Re: Turkey Point Units 3 and 4
Docket Nos. 50-250 and 50-251
Response to Request for Additional Information (RAI) Regarding Alternative
Source Term Amendment Request (TAC NOS. ME1624 and ME1625)

Response to 12/17/2009 RAI Regarding AST Related Modifications

Figure 1 – Planned Routing of CREVS Air Intakes

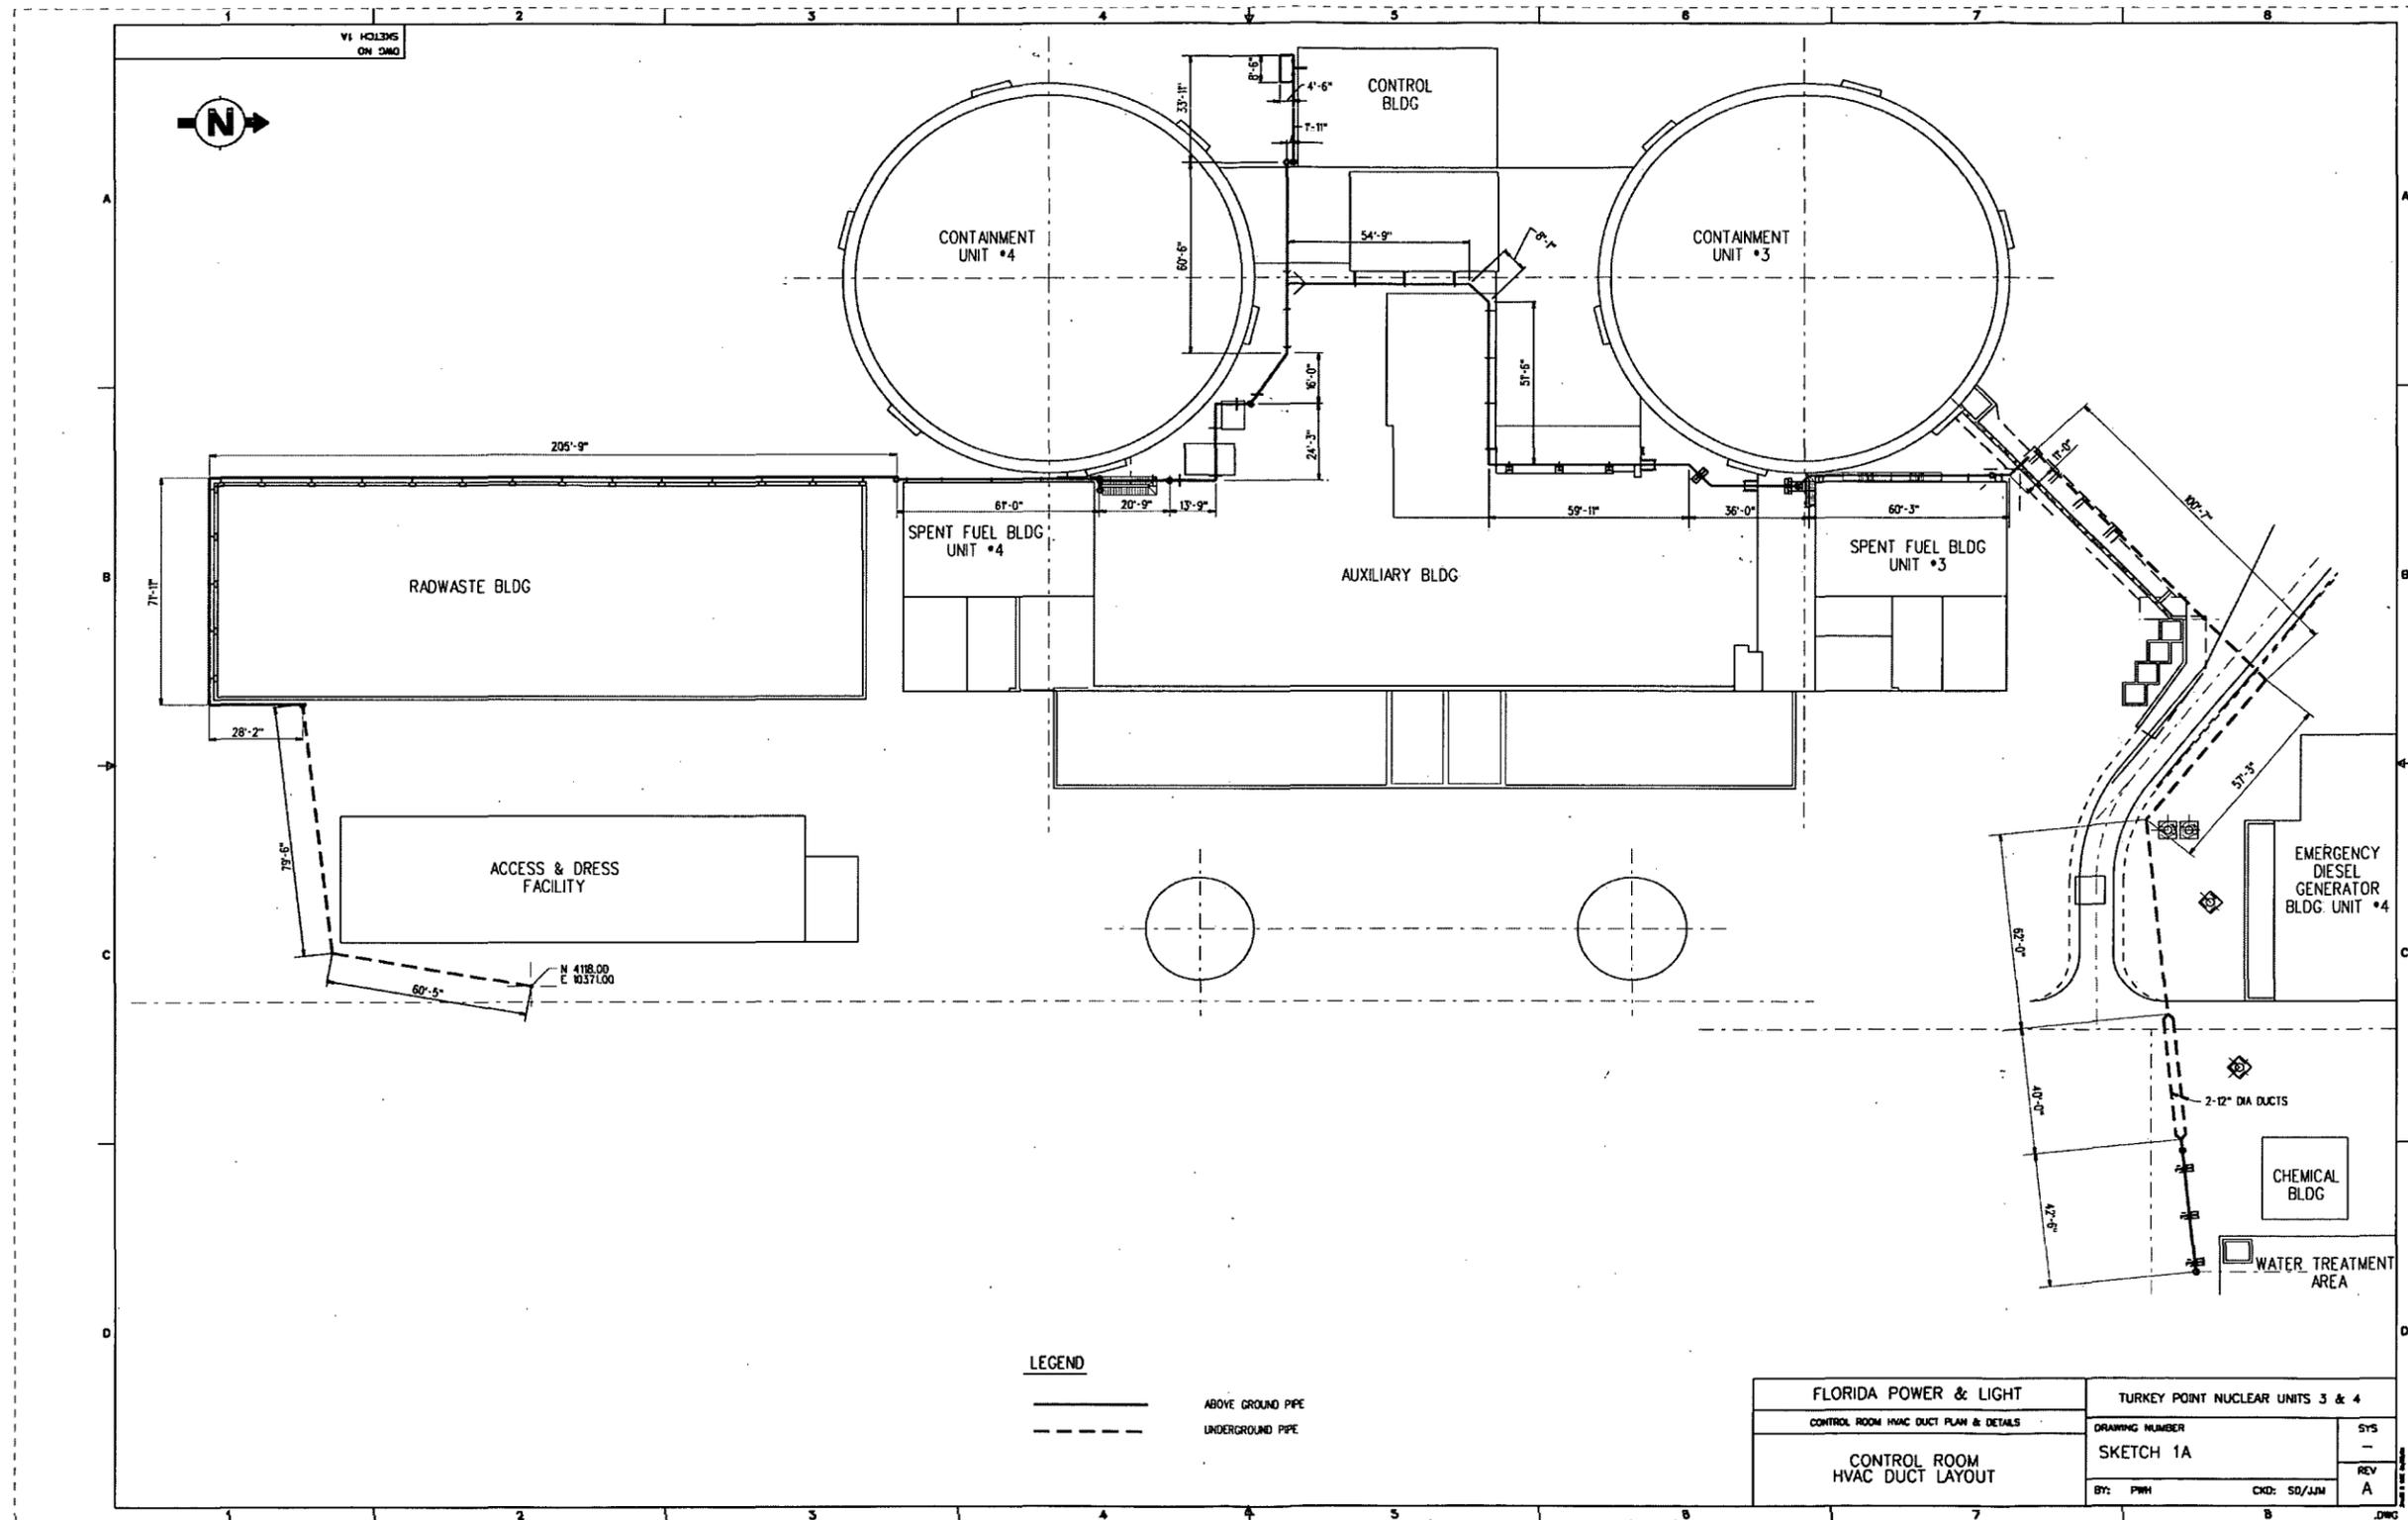
- a. Provide a sketch showing the relocated air intakes and duct work.***
 - b. Provide the results of the structural analysis of the relocated intake ducts and associated duct work, showing that the maximum stresses meet the design basis acceptance criteria under the safe shut-down earthquake and tornado loading.***

The new air intakes will be located away from the auxiliary building. The existing outside air damper design will be modified from its east-west intake configuration to a parallel configuration feeding a common duct running east over the auxiliary building roof and then splitting into two separate runs to the new southeast and northeast air intakes. One intake is currently planned to be located approximately 298 feet east and 190.5 feet south adjacent to the access and dress facility at Elevation 18'-6" while the other is to be located approximately 328.5 feet north and 350 feet east adjacent to the water treatment area at Elevation 16'-6". All of the positions of the old and new air intakes provided here are relative to the existing CREVS air intake penetration into the control building.

In order to achieve this, the new CREVS air intake duct routing is planned to be run from its penetration in the south wall of the mechanical equipment room along the control building wall and over the auxiliary building roof before splitting into two headers. The southeast header will continue around the Unit 4 containment building over the auxiliary building roof, along the Unit 4 spent fuel building and radwaste building roofs, then underground along the south and east side of the access and dress facility where it ends. The northeast header will continue around the Unit 3 containment building over the auxiliary building roof, along the Unit 3 spent fuel building roof, underground along the Unit 3 containment ramp, under the haul road, along the Unit 4 emergency diesel generator building, splitting into two parallel 12" headers to avoid interferences under the heavy haul road and then recombining into a single header again above ground just south of the water treatment area. See Figure 1 for the planned routing of the southeast and northeast air intakes.

Figure 2 – Planned Unit 3 Basket Locations

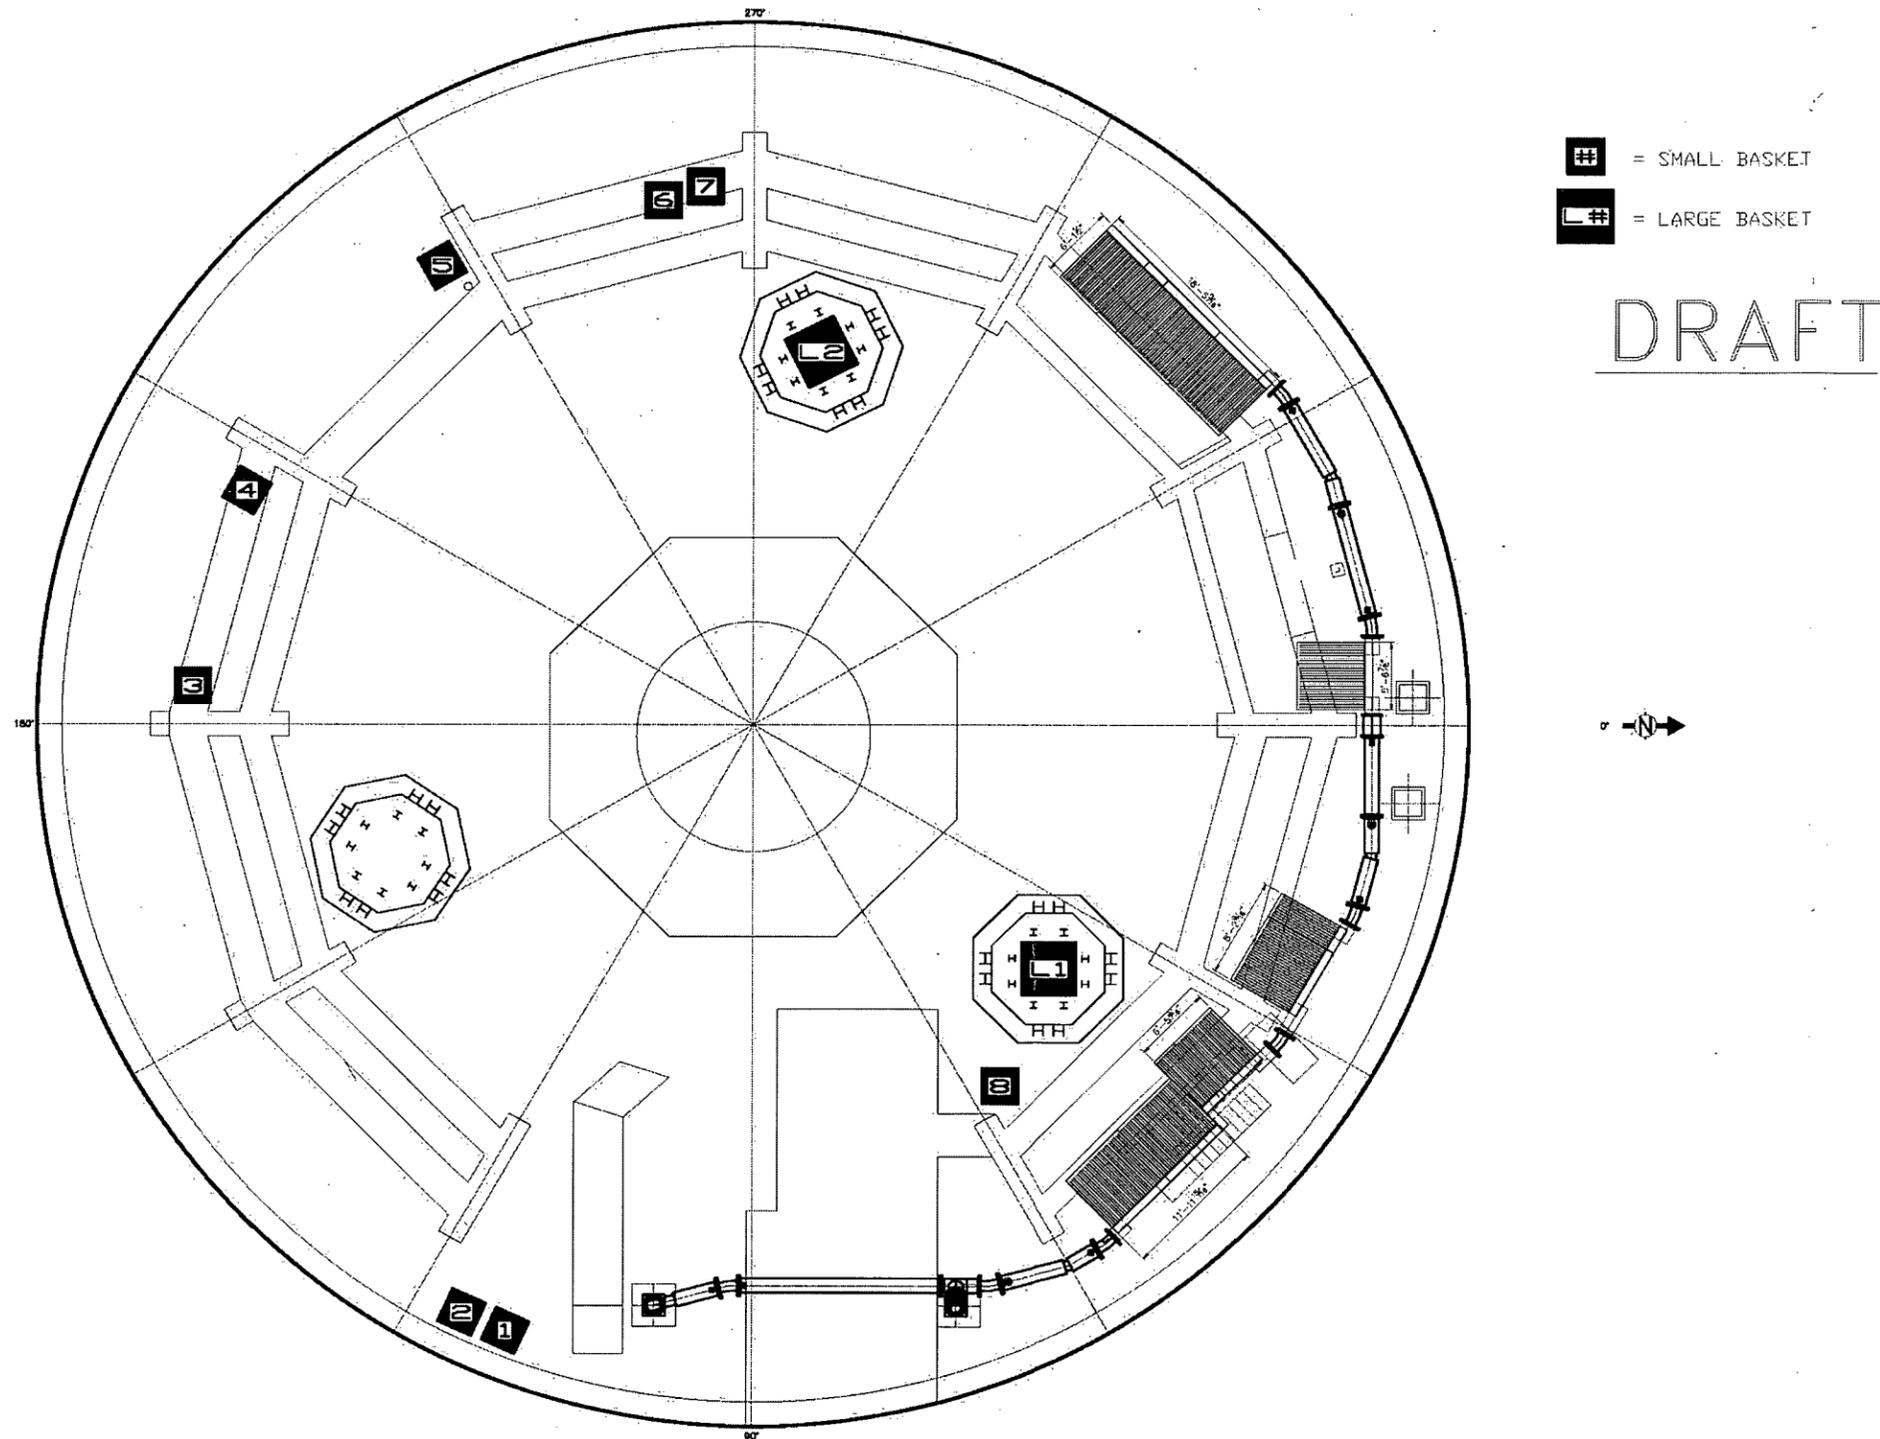
- 2. FPL stated on p. 14 of 20 of Attachment 2 to the Enclosure that it intends to install 10 stainless steel wire mesh baskets (two large and eight small) containing sodium tetraborate decahydrate (NaTB) in the containment basement, as a means of controlling the containment sump pH. These baskets contain a combined mass of 11,061 lbm of NaTB. Provide a detailed description of the structural design and analysis of these baskets, including the location, geometry, anchoring, the design loads and load combinations, design acceptance criteria and margins under normal and accident conditions.***

The basket locations have been chosen such that (1) the baskets will avoid seismic interaction with safety-related SSCs, and (2) the baskets will be out of the zone of influence of any potential High Energy Line Breaks (HELB). Based on the current design, the eight small baskets will be located outside of the biological shield wall (with the exception of basket #8 in Unit 3) while the two large baskets will be located within the shield wall in each unit. See Figures 2 and 3 for basket location details for Unit 3 and Unit 4, respectively.
